Southern Nuclear Operating Company  
Vogtle Electric Generating Plant Units 3 and 4  
Request for License Amendment and Exemption:  
Main Control Room Emergency Habitability System (VES) Design Changes (LAR-15-006)

**Main Control Room Emergency Habitability System (VES) Design Changes**

**(LAR-15-006)**

**Proposed Changes to Licensing Basis Documents**

**COL Appendix C Figure 2.2.5-1 and corresponding Plant-Specific Tier 1 Figure 2.2.5-1, Main Control Room  
Emergency Habitability System**

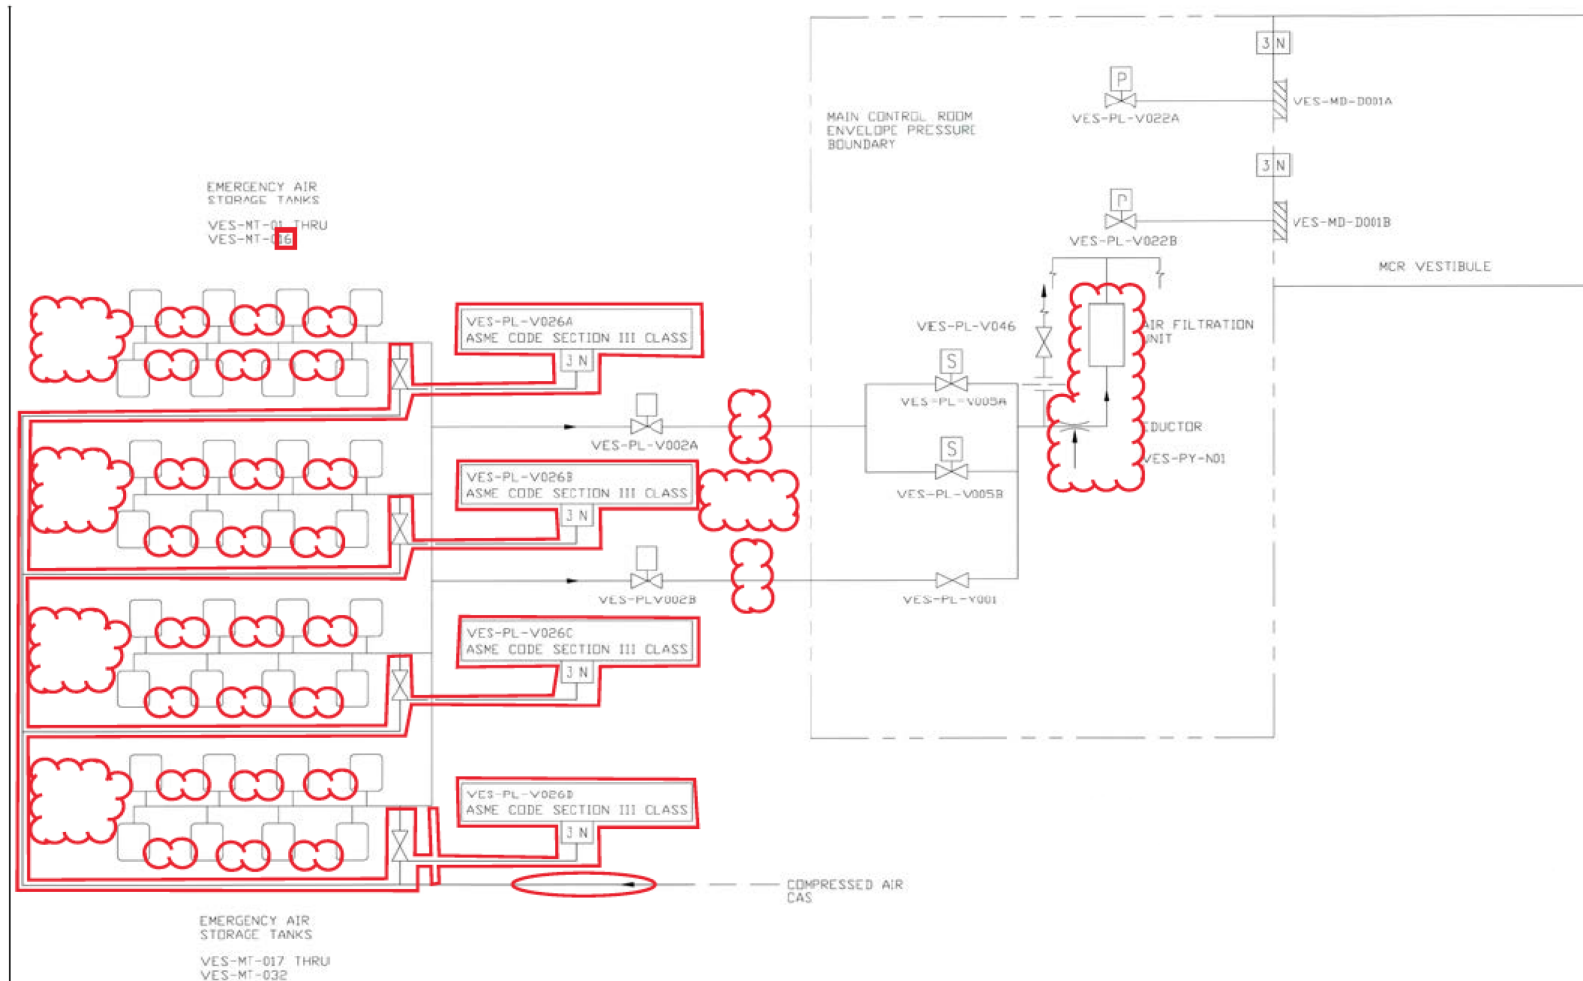
1. COL Appendix C Figure 2.2.5-1 is revised as follows:

- a) The orientation of the MCR air filtration line eductor is changed so that the emergency air storage tanks are connected to the motive air inlet of the eductor and the MCR air inlet is connected to the suction tap of the eductor;
- b) Add an air bank fill / vent header with an air tank fill / vent isolation valve at each of the four air banks;
- c) Move the ASME Code classification transition (Class 3 to nonsafety-related) to immediately upstream of the proposed air tank fill / vent isolation valves;
- d) Remove the refill line isolation valve (refill line isolation valve VES-PL-V038);

e) Remove the flow control orifices (flow restricting orifices) downstream of the pressure regulating valves VES-PL-V002A and VES-PL-V002B;

f) Change the designation of the emergency air storage tanks in the upper banks from VES-MT-01 thru VES-MT-18 to VES-MT-01 thru VES-MT-16; and

g) Remove the ASME Code classification transition at the emergency air storage tanks at eight locations.

Revise Figure as shown below:

**UFSAR Figure 6.4-2 (Sheet 2 of 2) Simplified Main Control Room Habitability System Piping and Instrumentation Diagram (REF) VES 002**

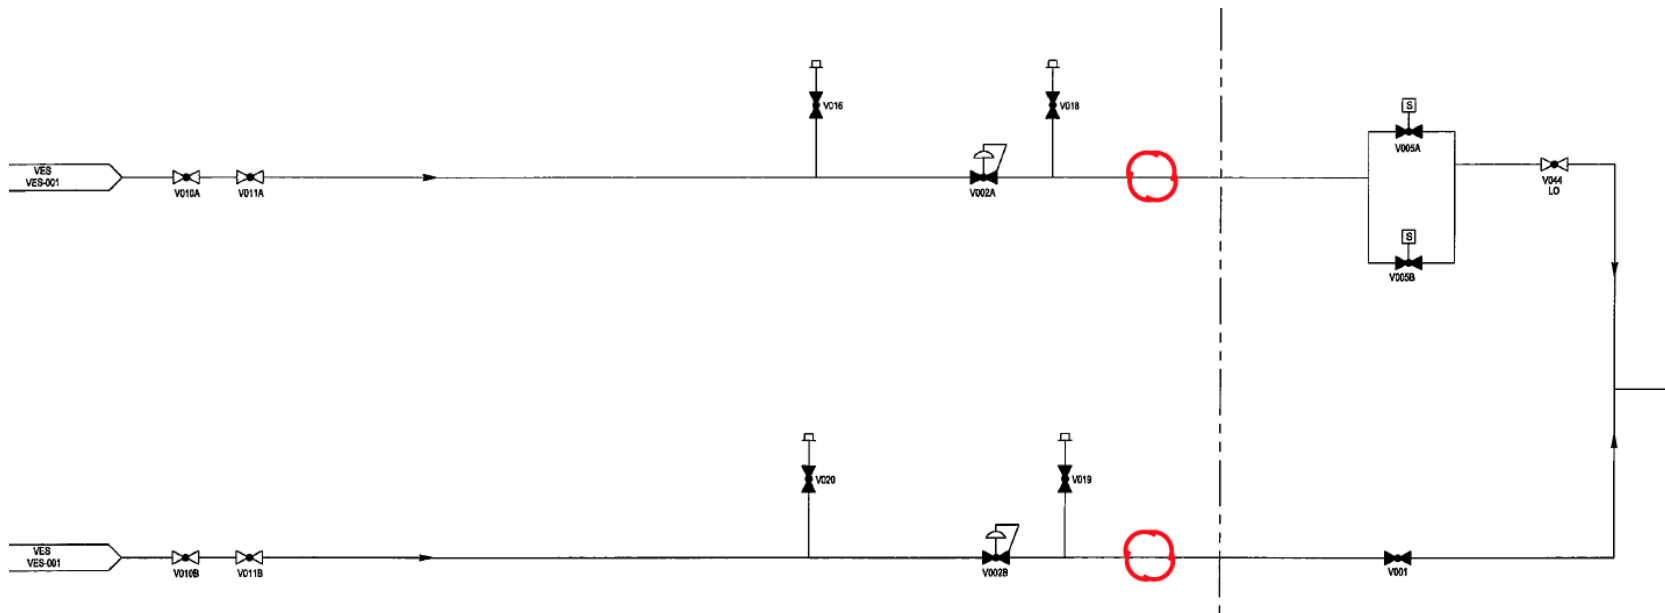
3. UFSAR Figure 6.4-2 (Sheet 2) is revised as follows:

a) The orientation of the MCR air filtration line eductor is changed so that the emergency air storage tanks are connected to the motive air inlet of the eductor and the MCR air inlet is connected to the suction tap of the eductor; and

b) Remove the flow control orifices downstream of the pressure regulating valves VES-PL-V002A and VES-PL-V002B.

Revise Figure as shown below:
